JFK Fashion Ltd.

Mowsayed, Uttarkhan, Uttara
(23.898021N, 90.437810E)

13th March 2017

Observations

Column Layout

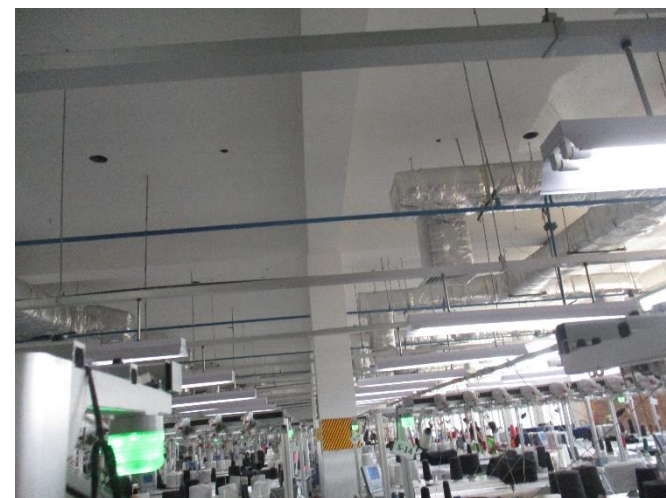
High Stress in Column

Cursory calculations indicate that all internal columns are highly stressed at ground floor. Building Engineer to review design, loads and columns stresses.

The reinforcement quantities recorded at Ground Floor level using the Ferro scanner coincided with the values provided in the Column Schedule. Brick aggregate was observed on-site. No loading plan was provided for the building.

Item No.	Observation	Recommended Action Plan	Recommended Timeline
1	High Stress in Column	Factory Engineer to review design, loads and columns stresses in area identified above.	Immediate - Now
2	High Stress in Column	Verify insitu concrete stresses either by 100mm dia. cores or existing cylinder strength data for [the identified columns] or [100mm dia. cores from 4 columns]	Immediate - Now
3	High Stress in Column	A Detail Engineering Assessment of Factory to be commenced, see attached Scope.	Immediate - Now
4	High Stress in Column	Produce and actively manage a loading plan for all floor plates within the factory giving consideration to floor capacity and column capacity.	6-weeks
5	High Stress in Column	Detail Engineering Assessment to be completed	6-weeks
6	High Stress in Column	Continue to implement load plan	6-months
7	High Stress in Column	Remedial works to be carried out if required.	6-months

Heavy water tank on roof

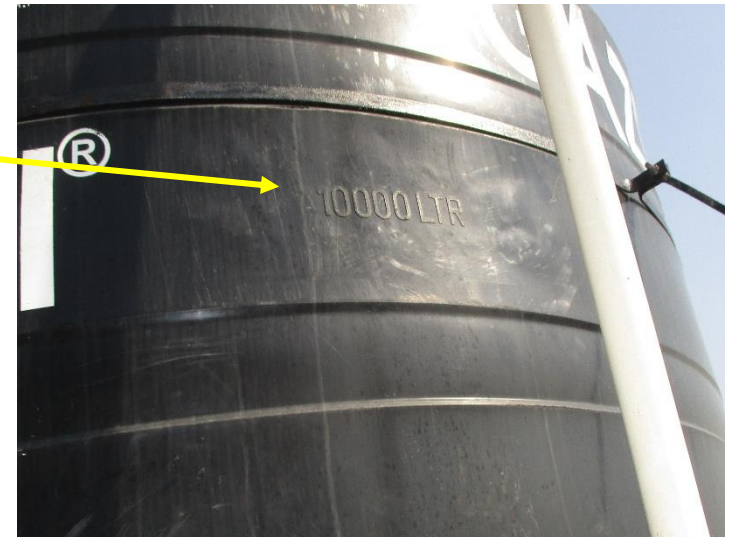
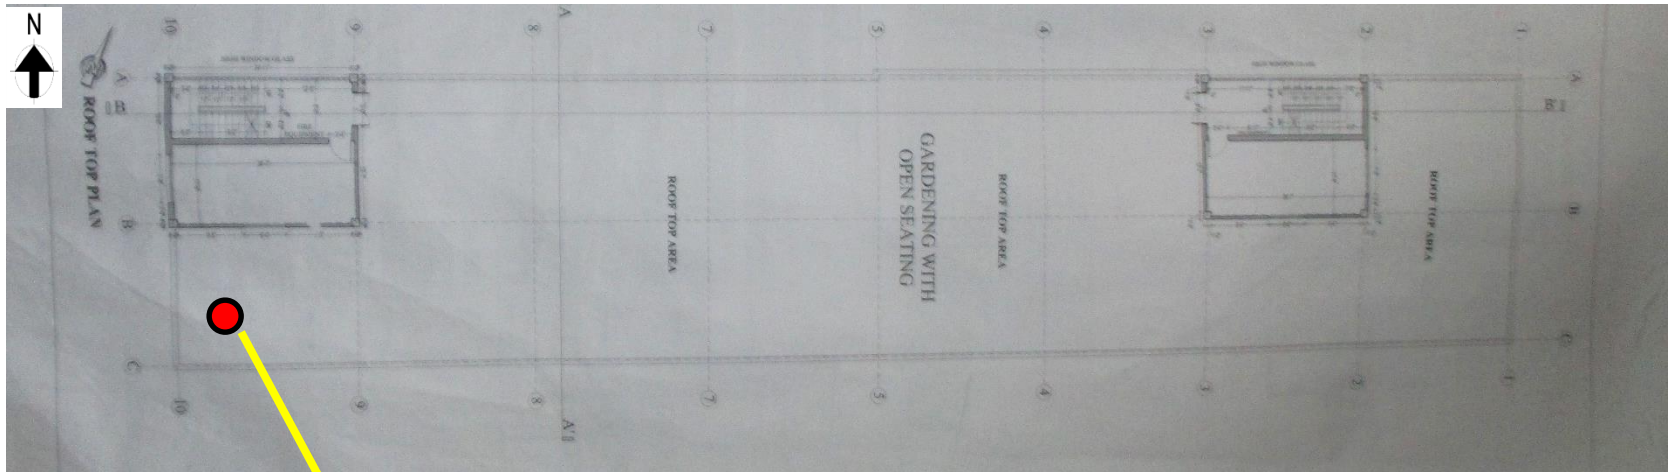
A 10000 liters capacity Over head plastic water tank was found at west side of roof. Factory engineer is required to check the adequacy of slab and beam .

8	Heavy water tank on roof	Provide calculations showing the structural adequacy of slab.	6-weeks
9	Heavy water tank on roof	Verify that supporting structures have adequate capacity to support heavy loading such as plastic water tank.	6-weeks
10	Heavy water tank on roof	Remedial works to be carried out if required.	6-months

Rafter Joint

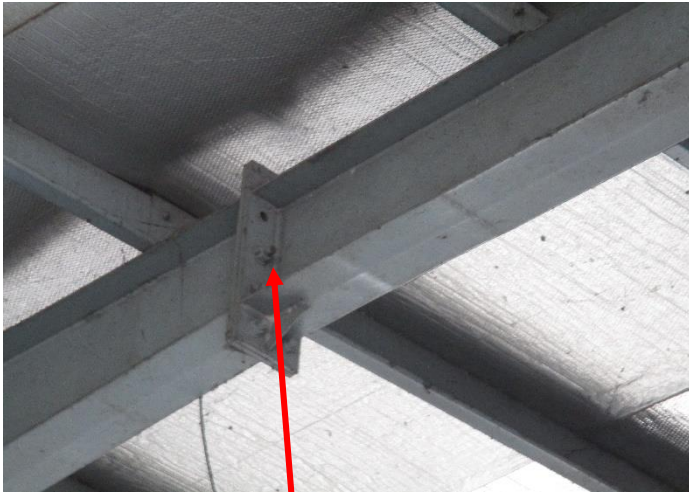
Bolt missing at rafter connection & Roof Bracing does not continuous to end

Bolt missing at rafter joint

At south roof bracing does not continuous to end. Bracings are shown yellow in picture.

Item No.	Observation	Recommended Action Plan	Recommended Timeline
11	Lack of Structural drawing for steel structure	Engage an Engineer to produce an “as constructed” drawings which reflect the actual site dimensions with complete structural information's.	6-weeks
12	Bolt missing at rafter connection & Roof Bracing not continuous to end	Install missing bolt and bracing as per bracing layout.	6-weeks
13	No water proofing at roof	Waterproofing on the roof slab is to be applied	6-weeks
14	Columns susceptible to vehicle impact	Install a barrier to prevent vehicle impact in column	6-weeks
15	Non-engineered external steel Stair	Engage Building Engineer to check load bearing capacity of external escape stair and to ensure adequate stability and connections are provided.	6-weeks

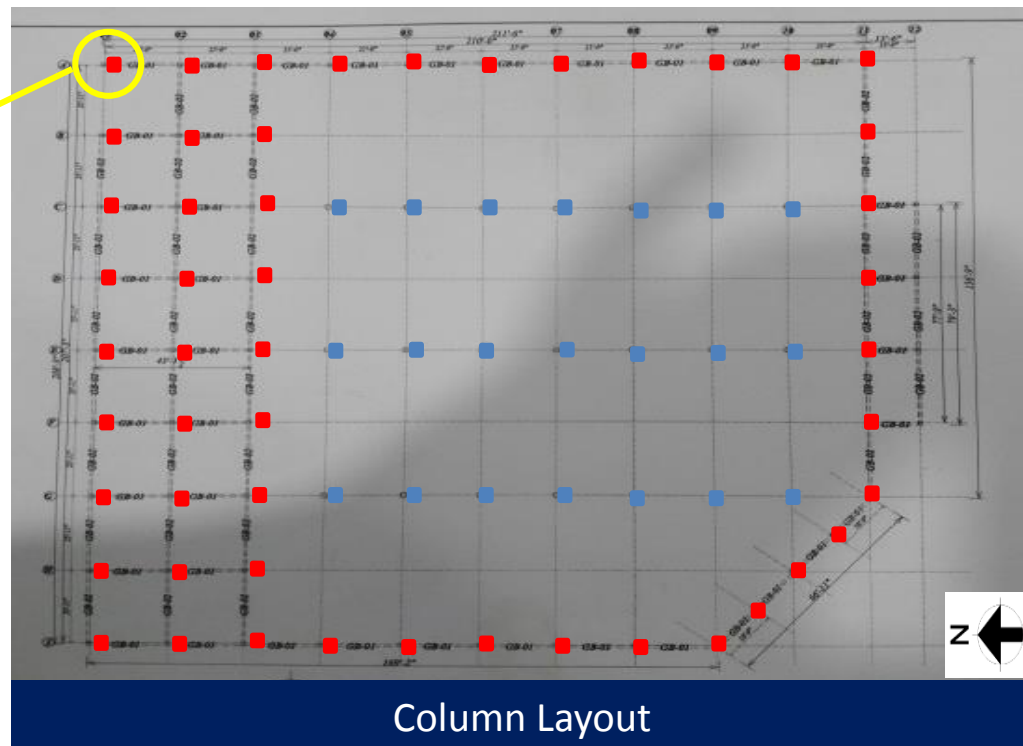
No water proofing at roof

No water proofing was observed at roof and aggregates were expose to air in some areas.
